## CITY OF ALLENSTOWN

**R197 – 2025**

### **Certificate of Appropriateness for work in the Historic Districts:**

**HDC-2025-00091**

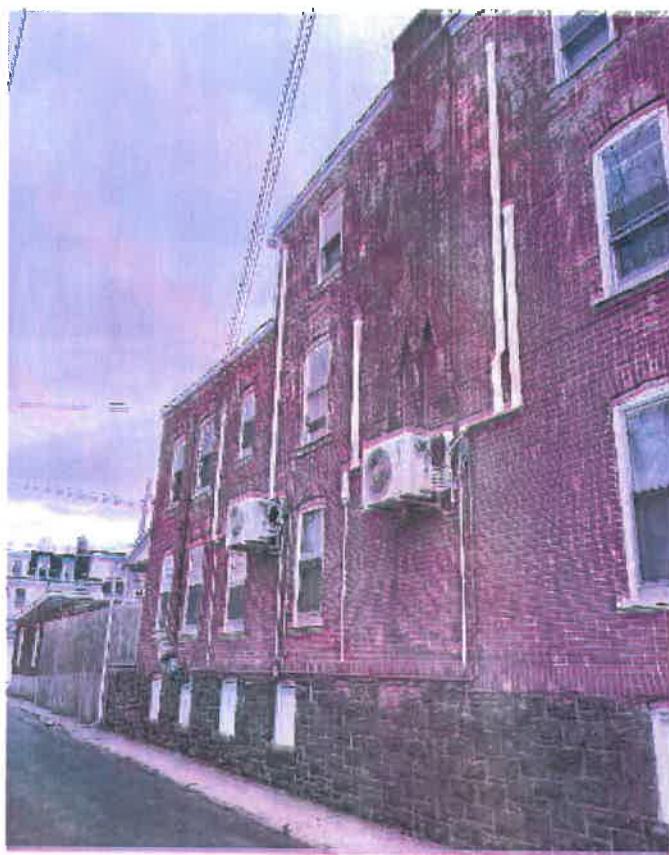
**Observations & Comments:** This application follows the denial of the legalization of the mini-split installation at the October 6, 2025, HARB meeting. The current HVAC system is installed on the exterior wall of a corner building, along Emmett Street. Two units are mounted on the wall near the top of first floor windows and various equipment lines are routed across the wall surface.

The applicant's proposed modifications indicate that the wall-mounted units would be located on the roof. This is a more appropriate approach to locating the units. Further discussion with the applicant will be helpful to determine if it is feasible for the units to be set back from the roof edge so that they are not visible from a public right-of-way.

The current Slimduct lines are white and highly visible on the exterior. The applicant's proposal to paint the Slimduct to match the exterior brick is appropriate to make these elements more inconspicuous and blend in. The proposed work includes brick repair. More information would be helpful to understand the intent, location, and materials used in brick repair.

**Staff Recommendation:** More information would be helpful to understand the scope of the brick repair. Regarding the mechanical system reconfiguration, staff recommend approving the application with the following conditions:

- The roof-mounted mechanical units are set back from the roof edge so that they are not visible from a public right-of-way.
- Brick repair is performed so that any units and mortar match the existing in dimension, materiality, texture, pattern, and color.

- The roof-mounted mechanical units are set back from the roof edge so that they are not visible from a public right-of-way; minimum 5'

- Brick repair is performed so that any units and mortar match the existing in dimension, materiality, texture, pattern, and color. This would be sent to staff for approval.
- As demonstrated in submitted photos and in discussion, all Slimduct lines would be routed vertically to avoid major horizontal runs.
